**TOWN OF LOS GATOS
PLANNING COMMISSION AGENDA
AUGUST 12, 2026
110 EAST MAIN STREET
TOWN COUNCIL CHAMBERS
7:00 PM**

DATE: August 7, 2026
TO: Planning Commission
FROM: Joel Paulson, Community Development Director
SUBJECT: Consider an Appeal of a Community Development Director Decision to Approve Construction of a Second-Story Addition Exceeding 100 Square Feet on Property Zoned R-1:10. **Located at 127 Belhaven Drive.** APN 527-29-031. Minor Residential Application MR-26-005. Categorically Exempt Pursuant to the California Environmental Quality Act, Section 15301: Existing Facilities. Property Owner: Jeremy Butcher. Applicant: Greg Stowers. Appellant: Sharad Gandhi. Project Planner: Suray Nathan.

SUBJECT: 127 Belhaven Drive/MR-26-005

127 BELHAVEN RESIDENCE WINDOW AT PRIMARY BATHROOM TOILET ROOM

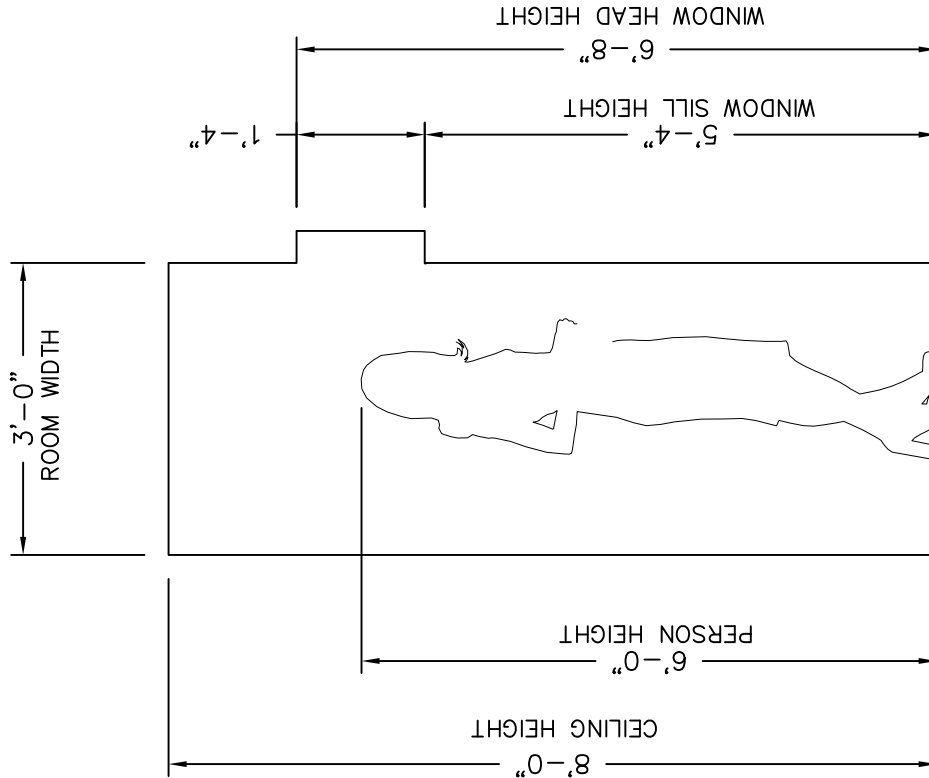
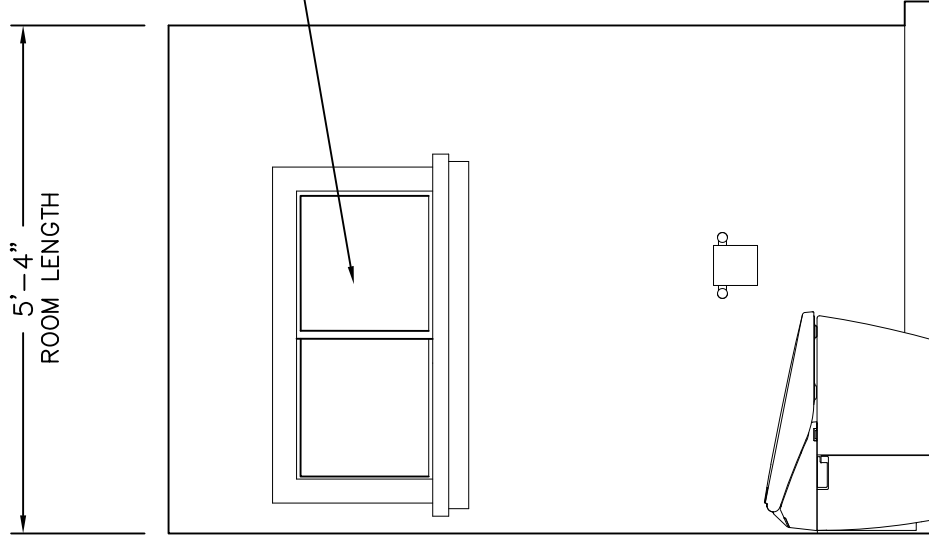
The architect has proposed interior window coverings as a means of addressing my privacy concerns. While I appreciate that proposal, interior blinds or shades are occupant-controlled features that may be opened, removed, or replaced over time. As such, they do not provide a permanent architectural privacy solution.

1. Require permanently obscured or frosted glazing for Window 02.
2. Request dimensioned plans and supporting drawings sufficient to independently evaluate the revised project analyses, including the shadow study and the relationship of the proposed second-story addition to the existing residence.
3. If additional plans or supporting materials are submitted in response to these requests, provide an opportunity for public review before the Commission takes final action on the project.

3' x 1'4" SLIDER
WINDOW AT TOILET
ROOM. OWNER HAS
AGREED TO INSTALL
WINDOW COVERINGS
TO MATCH THE STYLE
OF THE REST OF THE
PRIMARY SUITE.

As stated in our letter of justification, the window in question is a 3-foot by 1-foot 4-inch clerestory window located within the enclosed toilet room of the new primary bathroom. This window is on the south elevation of the home and faces towards the street. The sill height is approximately 5 feet 4 inches above the finished floor.

PRIVACY STUDY AT PRIMARY BATH WINDOW
SCALE: 1/2" = 1'-0"

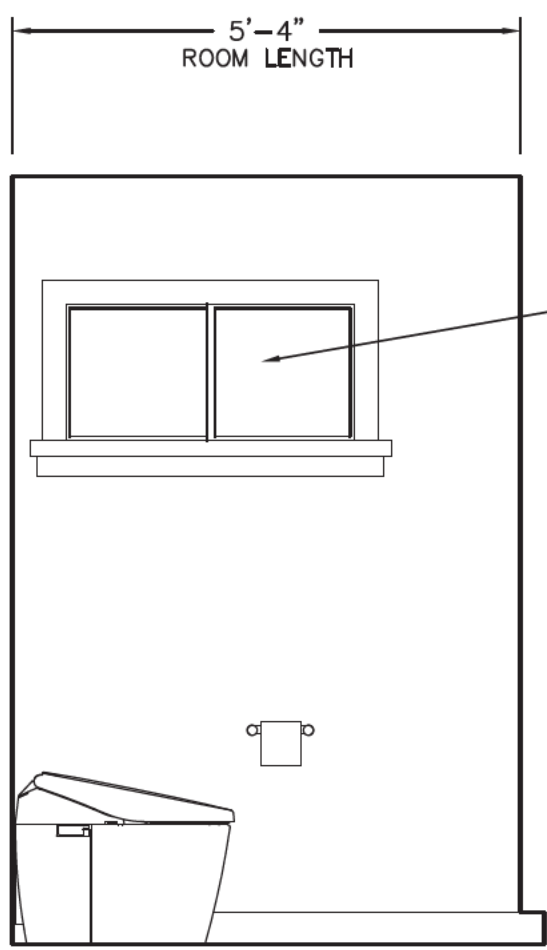
Staff response: Staff determined that a formal privacy impact analysis was not warranted for the street-facing clerestory window. Because the window serves a bathroom and features a high sill height of five feet, four inches, it naturally mitigates sightlines and preserves privacy.

Interior blinds or shades are occupant-controlled features that may be opened, removed, or replaced over time. They therefore cannot provide a permanent architectural privacy mitigation.

3' x 1'4" SLIDER WINDOW AT TOILET ROOM. OWNER HAS AGREED TO INSTALL WINDOW COVERINGS TO MATCH THE STYLE OF THE REST OF THE PRIMARY SUITE.

3 SIGHT LIGHT STUDY FROM NEW BALCONY TO NEIGHBORING PROPERTY
SCALE: 1/8" = 1'-0"

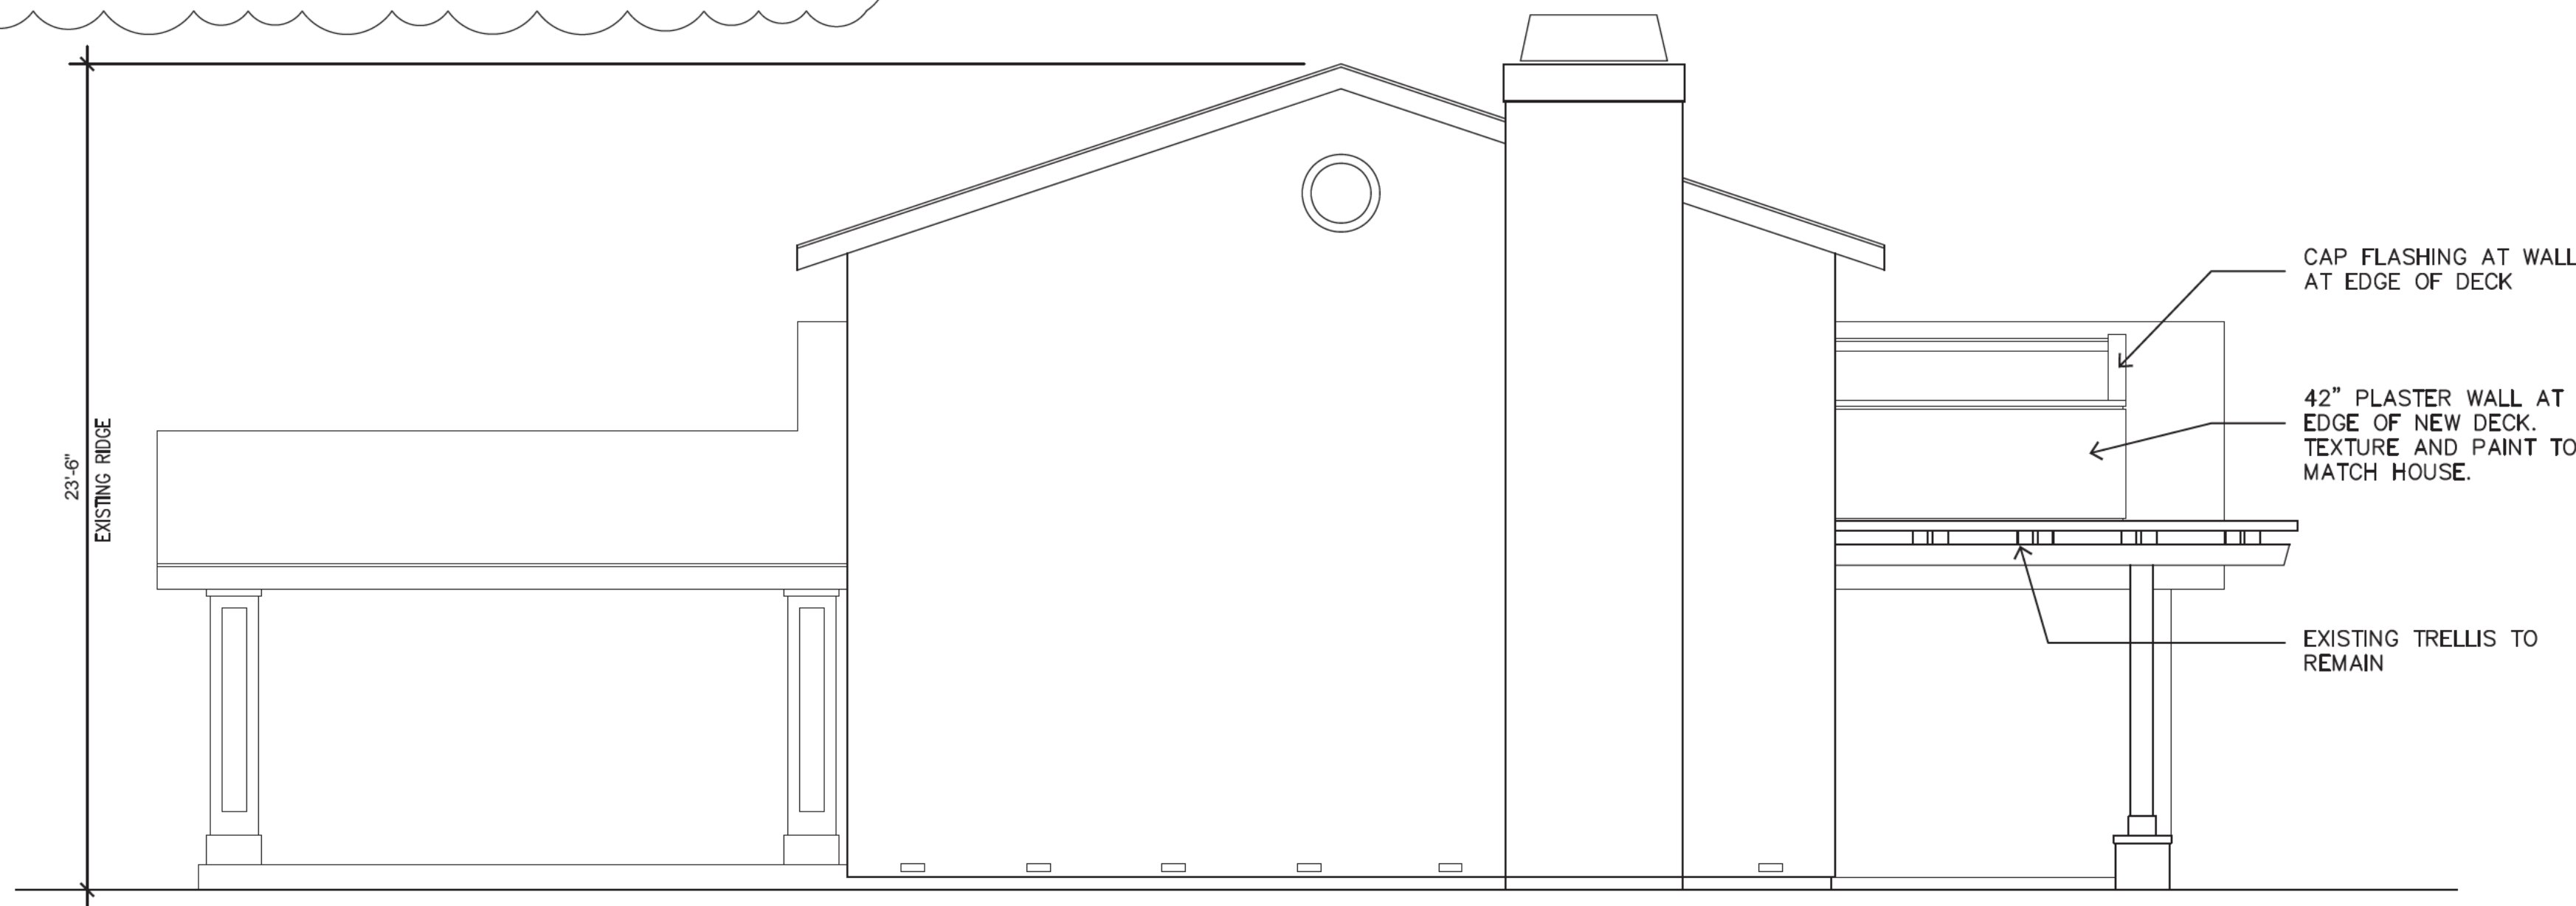
1. The most consistent recommendation would be to remove the deck from the front elevation. However, if the applicant can make a credible argument for including a balcony off of the primary bedroom, my recommendation would be to relocate it to the side façade as shown in the illustrations below. This would keep the front façade consistent with other residences in the immediate neighborhood, provide a more pleasant space for the homeowner, and would not create any privacy concerns for the adjacent residence since its side façade is largely a blank wall. The deck depth should be modest in depth to minimize its intrusion into the roof form visible from the street.

The most consistent recommendation would be to remove the deck from the front elevation. However, if the applicant can make a credible argument for including a balcony off of the Primary Bedroom, my recommendation would be to relocate it to the side facade as shown in the illustrations below. This would keep the front facade consistent with other homes in the immediate neighborhood, provide a more pleasant space for the homeowner, and would not create any privacy concerns for the adjacent home since its side facade is largely a blank wall.

Applicant Response: *The location of the new deck was thoughtfully determined with the owners. The consultant's proposal of moving the deck to the side yard does not meet the goals of the owners for the project. The neighbor to the right is located uphill of the project site, so having the deck nestled into the existing roofline provides a sense of privacy to the owners when they choose to sit on the deck. The deck is small, and primarily having the glass French door and the window will provide more light to the primary bedroom. The primary goal of the deck is to capture the distant view of the hillsides that is available from the deck in this location.*

Staff Response: *In evaluating the applicant's justification for maintaining the deck on the west elevation, rather than relocating it to the east elevation as recommended by the Consulting Architect, staff conducted a site visit to assess its visibility from the public right-of-way. Additionally, staff requested a cross-section and sight-line analysis to evaluate potential privacy impacts on the adjacent property to the west (Exhibit 11; Sheet A3.5). Based on the deck's positioning relative to the western neighbor and the downward slope of the lot toward the front façade, the Community Development Director determined that the deck is appropriately integrated with the existing architectural façade and poses no adverse privacy impacts to the neighbor to the west.*

2 SUN STUDIES FOR DECEMBER 21st AND JUNE 21st
SCALE: NTS

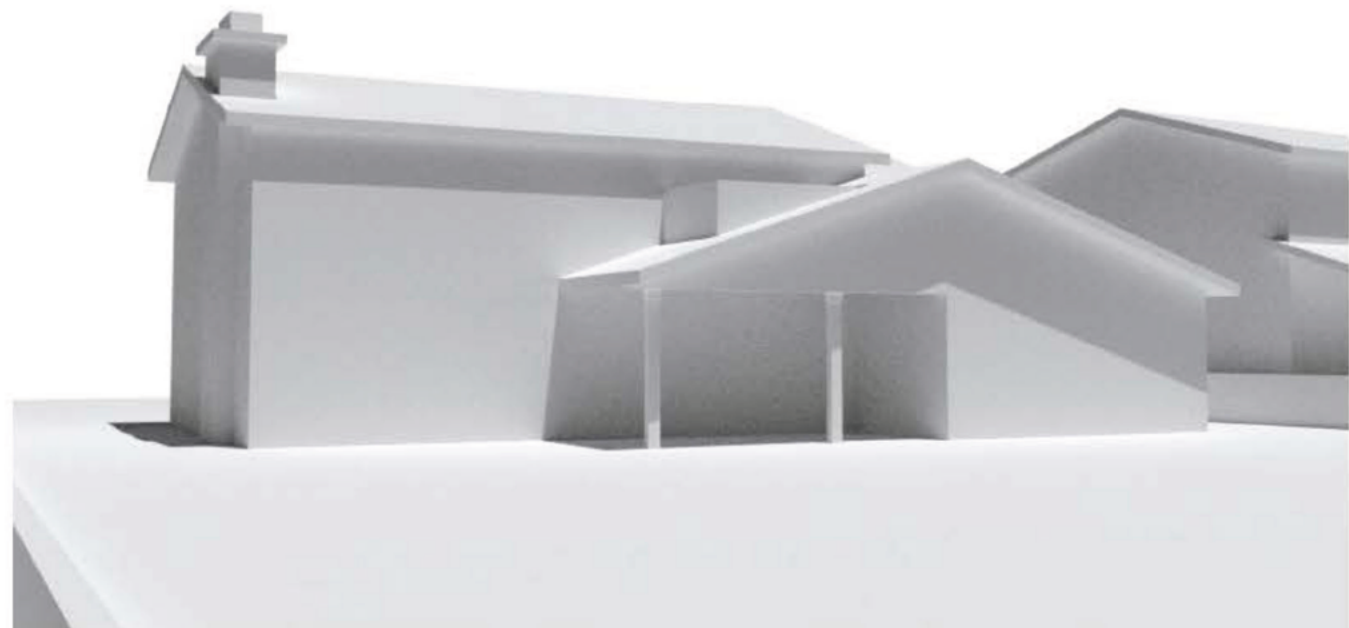
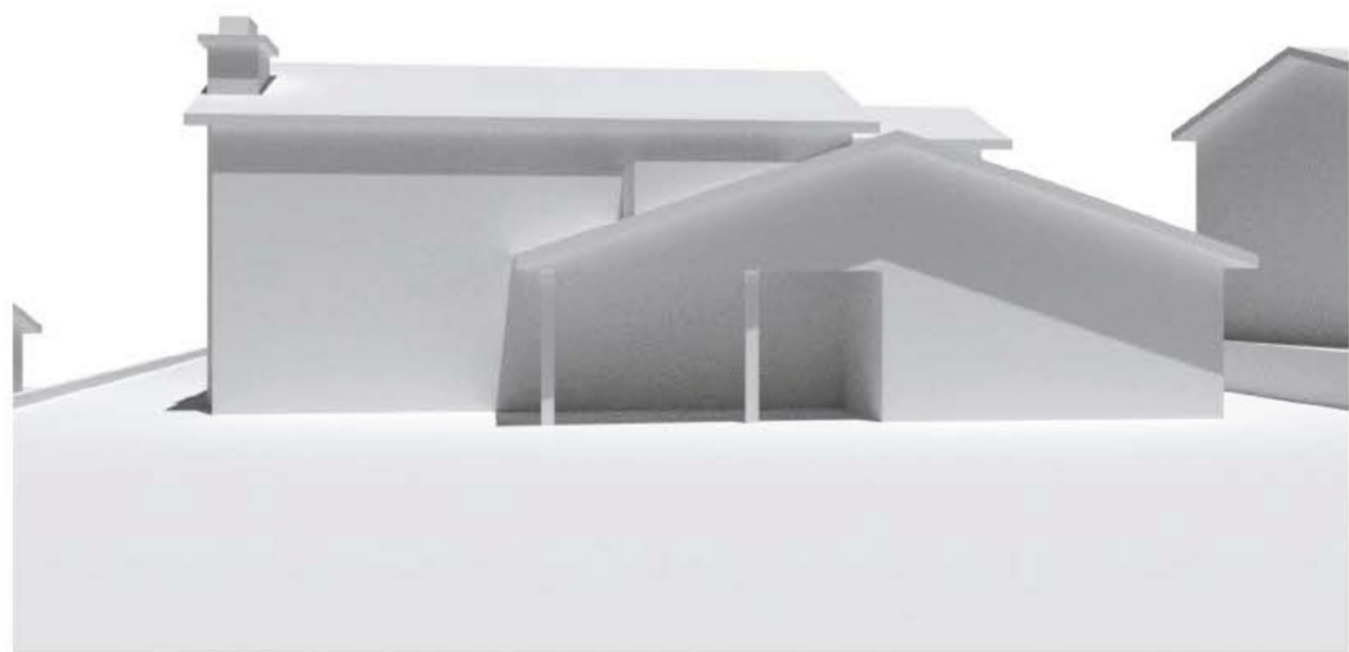
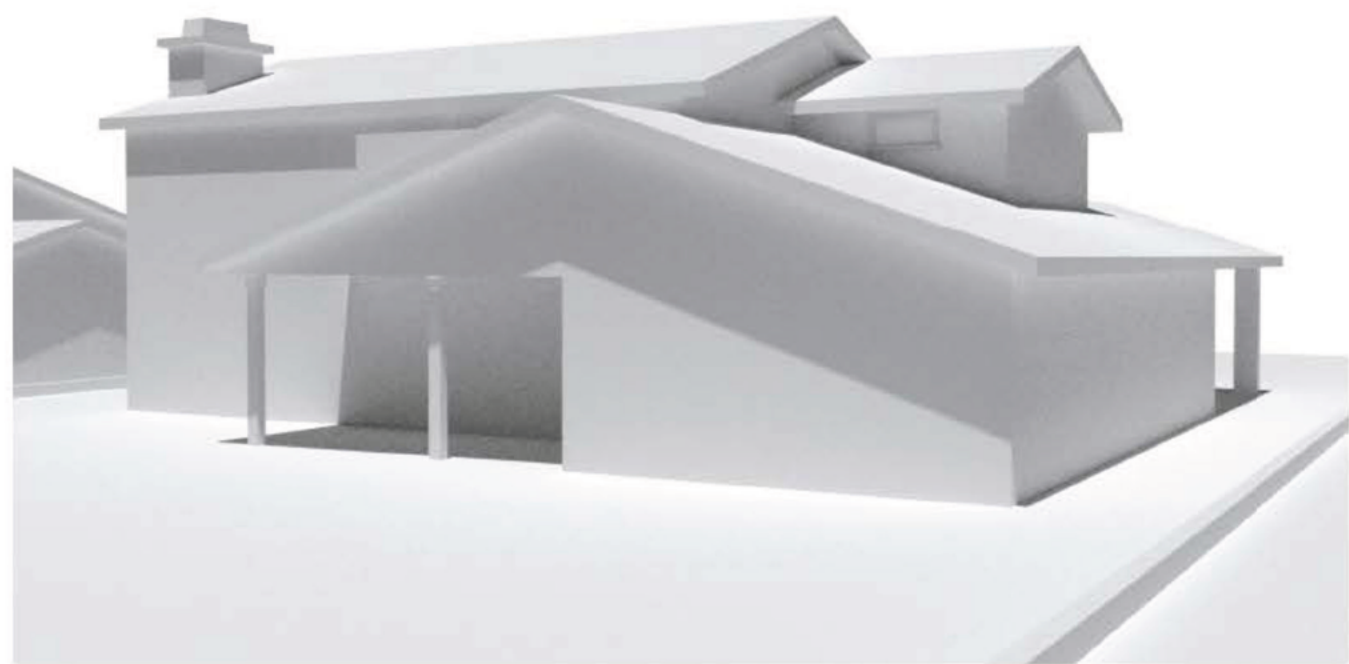
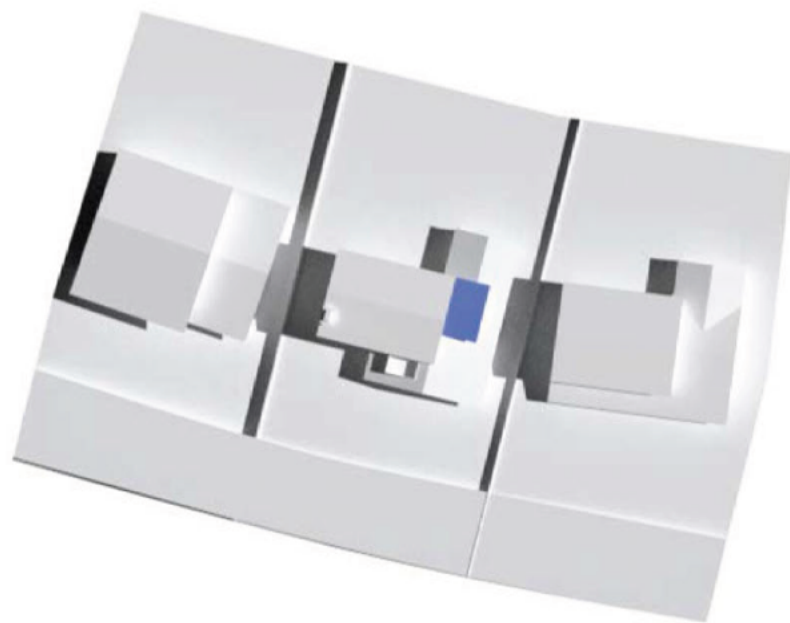
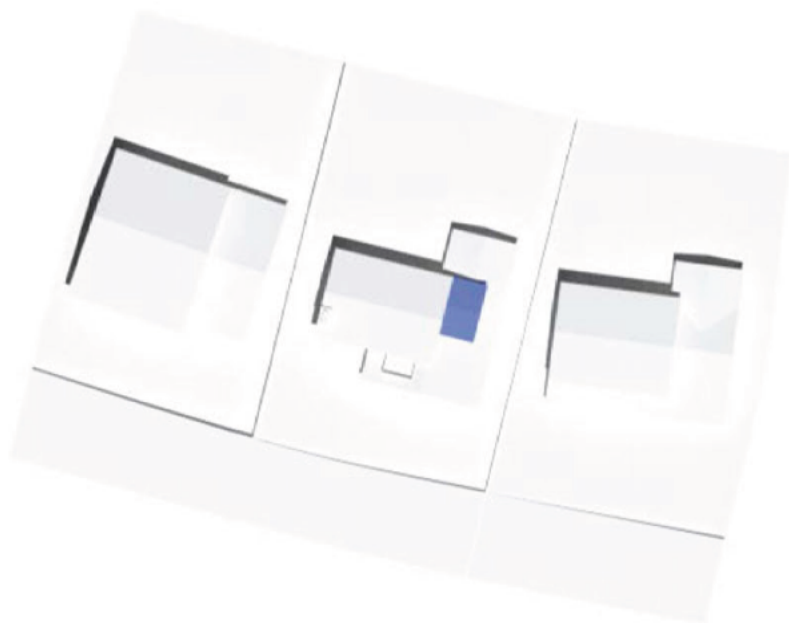
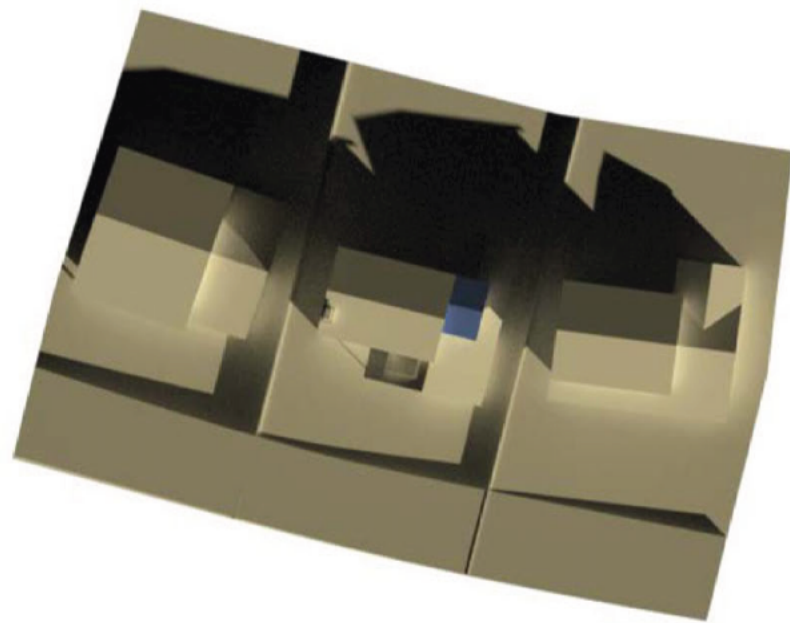
The appellant identified inaccuracies in the initial shadow study. In response, the applicant submitted an updated analysis on May 29, 2026, and a subsequent color-coded revision on June 24, 2026, to clarify potential impacts on the backyard. The revised study models shadows at 9:00 AM, 12:00 PM, and 3:00 PM during the summer (June 21) and winter (December 21) solstices. While the shadows reach their maximum extent at 3:00 PM on December 21, staff conclude that the proposed addition will not significantly impact the solar access of the adjacent property to the east (Exhibit 11, Sheet A5.4).

During the review process, the shadow study underwent multiple revisions to address the issues identified in earlier submissions. Although the revised analyses represent an improvement, I continue to believe the project record lacks sufficient objective, dimensioned information for neighboring property owners and the Planning Commission to independently understand and evaluate the analyses supporting the proposal.

Specifically, I have requested dimensioned drawings illustrating the relationship of the proposed second-story addition to the existing residence. Those drawings would provide an objective basis for evaluating both the proposed addition and the revised supporting analyses.

I understand the neighbor's concern for the contradictions in the sun-study, and I admit that there were errors in the original sun-study that was included on the plans. Subsequent studies were developed as an attempt for a quick response to the neighbor while I was out of the office and traveling abroad without access to my full systems. I have spoken directly with the neighbor and have apologized for the errors and the confusion. Upon returning from vacation, I completely rebuilt the computer model of the homes to verify dimensions and regenerated the sun-studies for the project. These are included on the plan set and they are accurate. This updated study has been provided to the neighbor.
